# Work Order ID 107455

Item Name: Crosstube Turning Detaill

<b>DART AEROSPACE LTD</b>	<b>Work Order:</b>	107455
<b>Description:</b> Crosstube Assembly (206L High Fwd)	<b>Part Number:</b>	D206-667-143
<b>Inspection Dwg:</b> D206-667-143 <b>Rev:</b> C		<b>Page 1 of 2</b>

DRAWING NO. D206-667-143	TITLE CROSSTUBE ASS'Y (206L HIGH FWD)	REV. C	<b>DART AEROSPACE LTD ENGINEERING ORDER</b>		D.E.O. NO. D206-667-143-C-1	SHEET NO. SHEET 1 OF 1	SCALE NTS
DRAWN <i>q</i>	CHECKED <i>ASS</i>	MFG. APPR. <i>[Signature]</i>	APPROVED <i>[Signature]</i>		DE APPR. <i>[Signature]</i>		
DATE 11.07.15	DATE 11.07.20	DATE 11.07.21	DATE 11/07/21		DATE 11.07.21

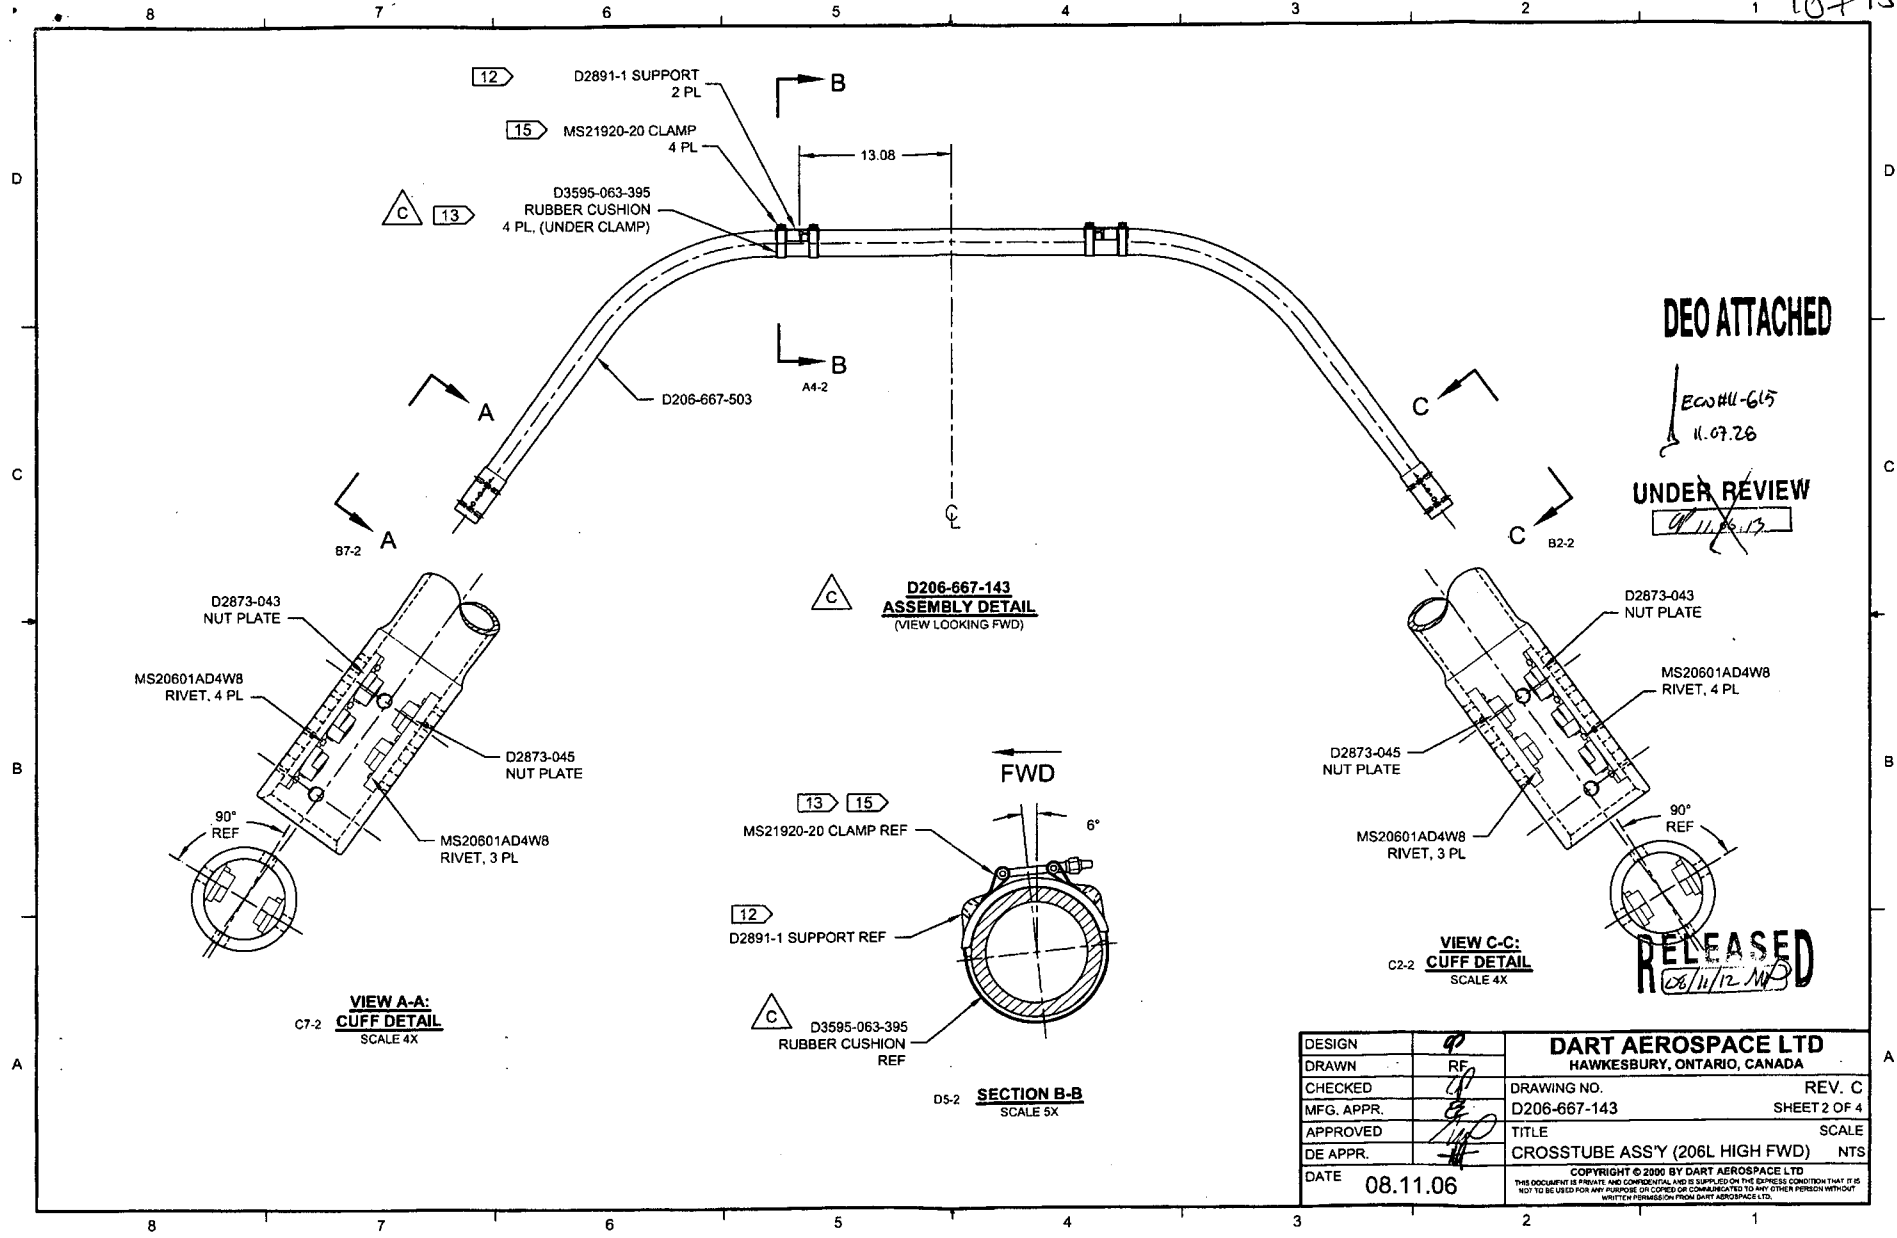
C	REVISE GENERAL NOTES/PART LIST (ZN D7-1); REORGANIZED VIEWS AND REFORMATTED DRAWING TO CURRENT STANDARDS. D3595-063-395 WAS D2856-400-694 (ZN D6-2 & A5-2); REMOVED REF. & ADD TOLERANCE (ZN D3-3, C4-3, C5-3); RELOCATED FLAG #6 (ZN A8-3) PER NCR 210; MOVED TURNING DETAIL & UPDATED TOLERANCE TO SHEET 4.	RF	08.11.08
B	ADD HOLES AND NUT PLATES FOR COMPATABILITY WITH BHT/AA SKUDTUBES	PH	05.07.26
A	NEW ISSUE	CP	00.11.17
REV.	DESCRIPTION	BY	DATE
DESIGN	RF		
DRAWN	RF		
CHECKED	RF		
MFG. APPR.	RF		
APPROVED	RF		
DE APPR.	RF		
DATE	08.11.06		
<b>DART AEROSPACE LTD</b> HAWKESBURY, ONTARIO, CANADA DRAWING NO. D206-667-143 REV. C SHEET 1 OF 4 TITLE CROSSTUBE ASS'Y (206L HIGH FWD) SCALE NTS <small>COPYRIGHT © 2009 BY DART AEROSPACE LTD THIS DOCUMENT IS PRIVATE AND CONFIDENTIAL AND IS SUPPLIED ON THE EXPRESS CONDITION THAT IT IS NOT TO BE USED FOR ANY PURPOSE OR COPIED OR REPRODUCED TO ANY OTHER PERSON WITHOUT WRITTEN PERMISSION FROM DART AEROSPACE LTD.</small>

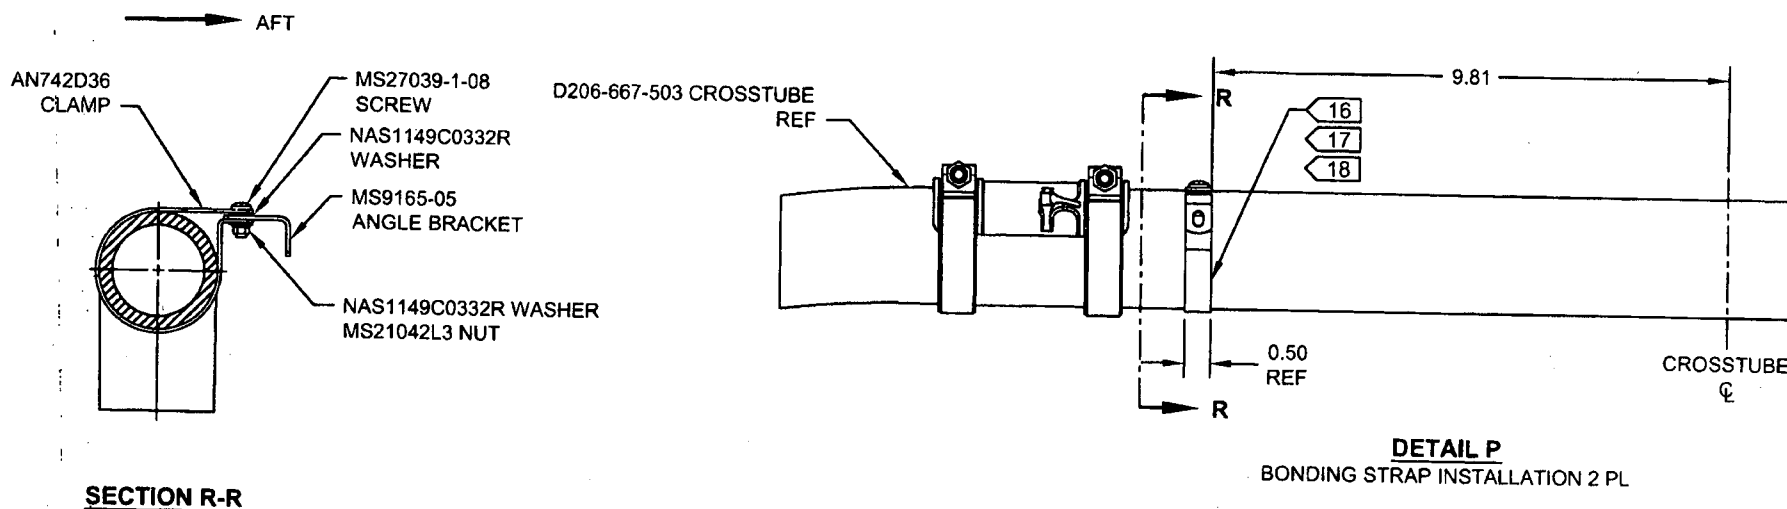
ADD ELECTRICAL GROUNDING STRAP

- 16) MASK AREA UNDER CLAMP PRIOR TO PAINTING
- 17) SEAL EDGES WHERE AN742D36 CLAMP MEETS WITH THE CROSSTUBE USING SIKAFLEX-241/-291 OR MIL-S-8802 CLASS B2 OR PROSEAL 890 SEALANT
- 18) PERFORM RESISTANCE CHECK TO ENSURE MAX RESISTANCE IS 10 MILLIOHMS
